THE CITY OF WICHITA

Re: Drainage Plan: David's East 2nd Addition

PROJECT: David's Replat

PROJECT: Chelsea Brooke

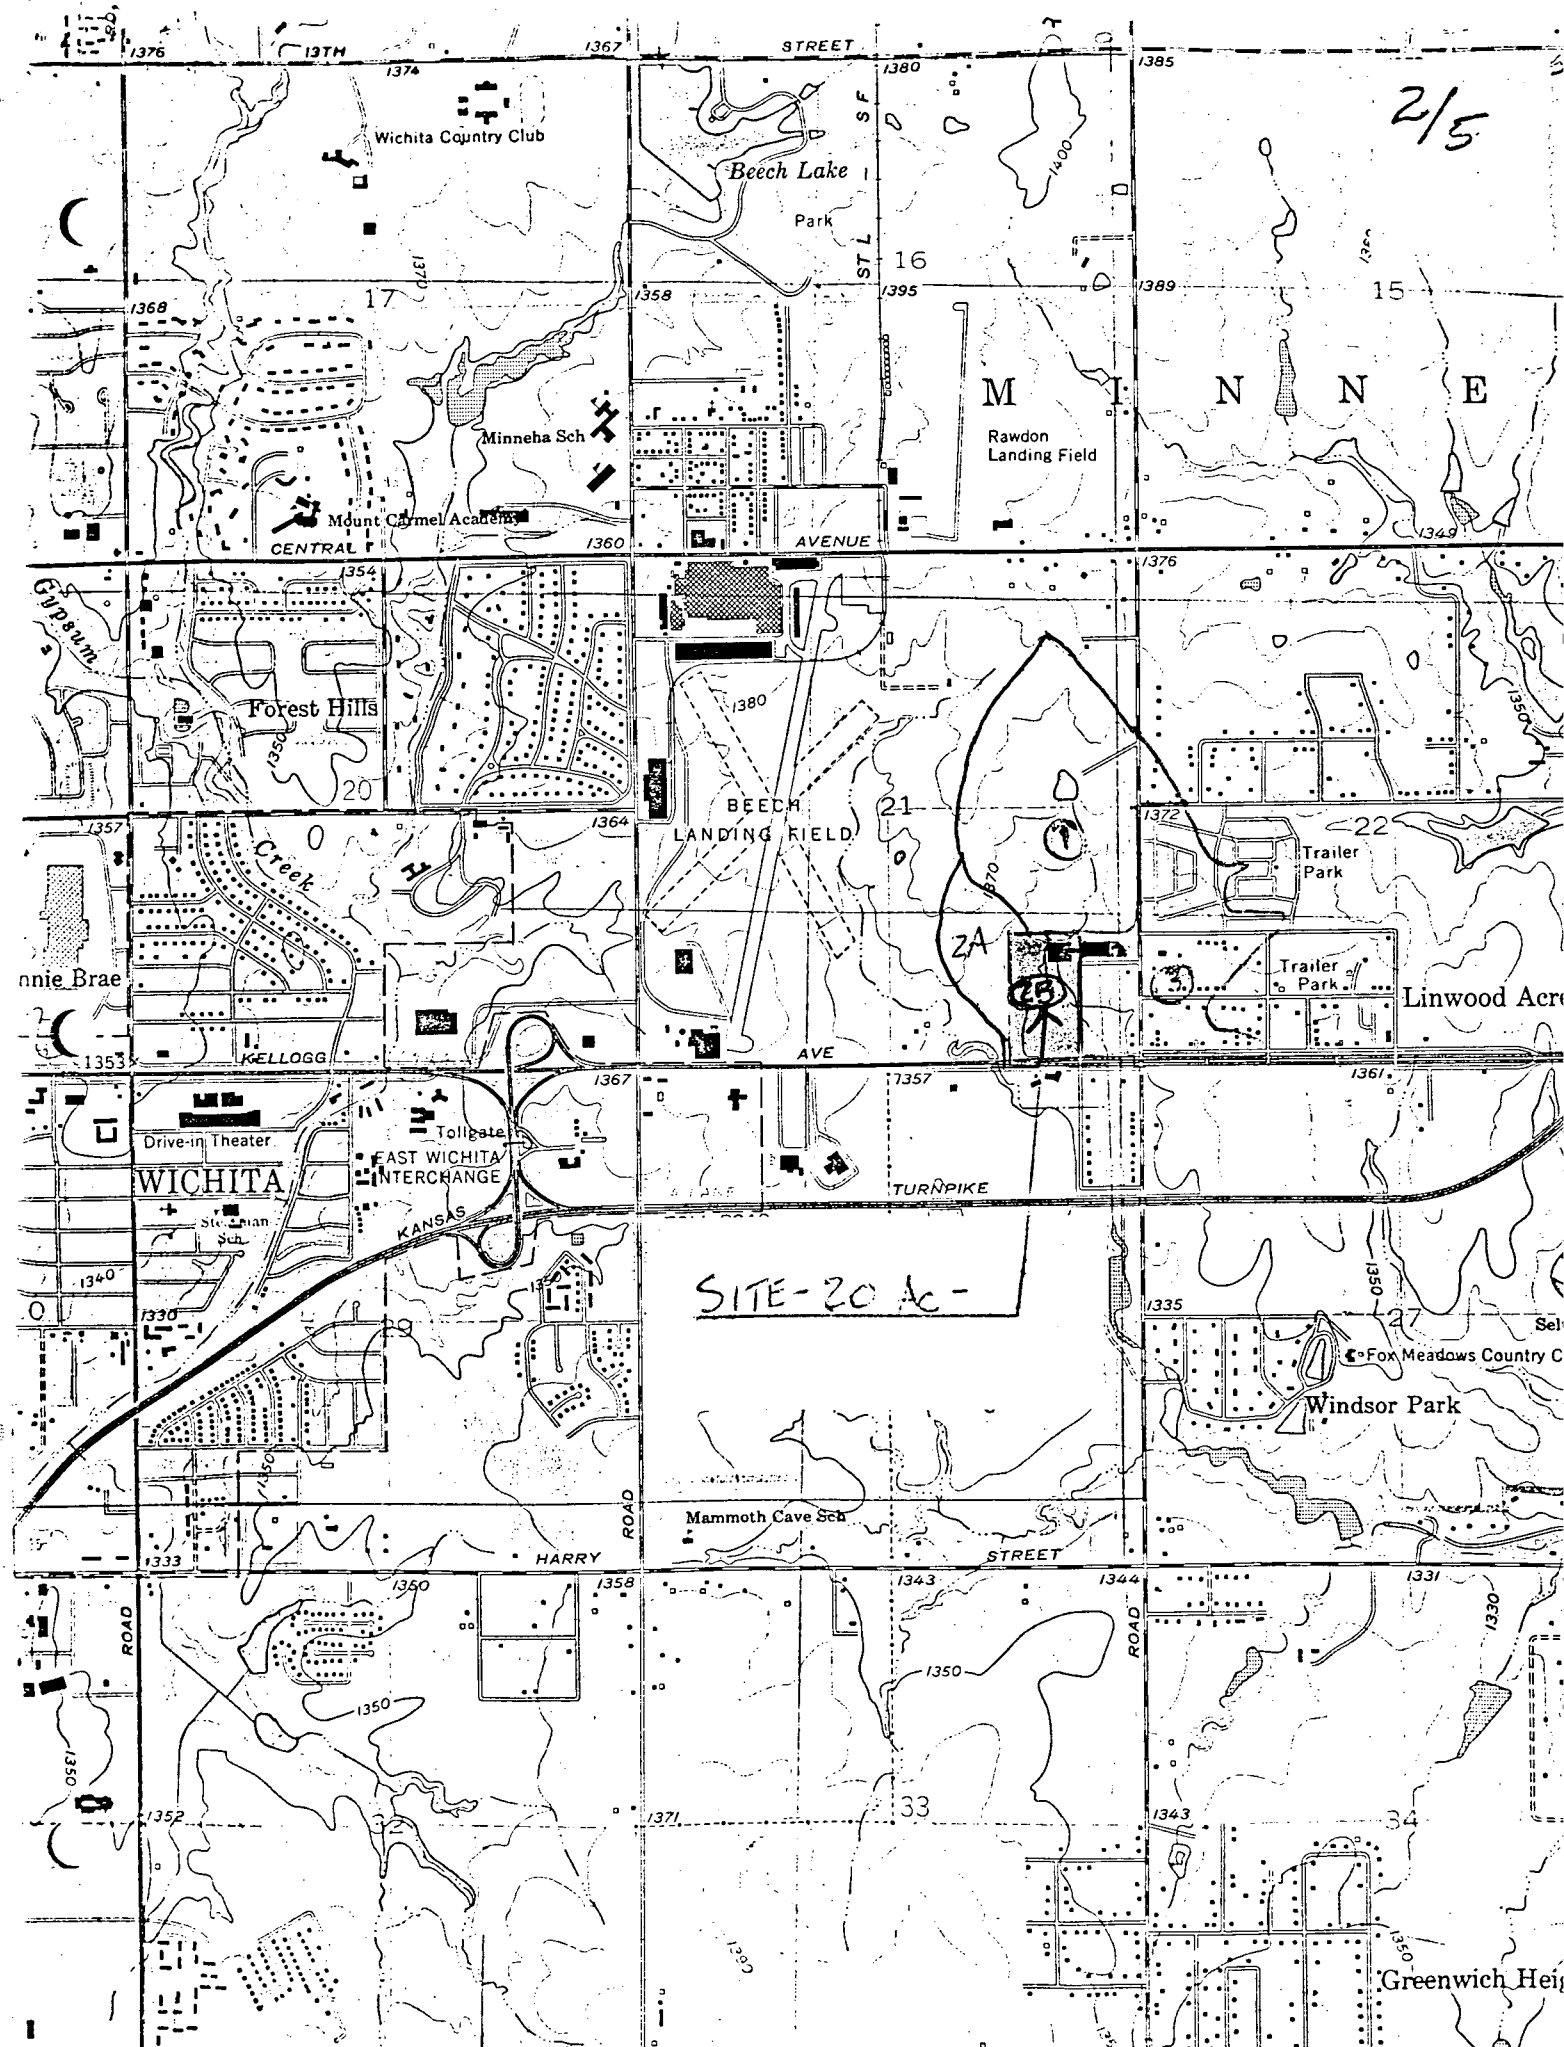
1. Need calculation to show a 5-acre detention pond has the storage capacity to reduce the peak run-off of the 138-Acre Beech drainage basin from 286 cfs to 40 cfs.
2. Is Beech agreeable to have the detention pond on their property?
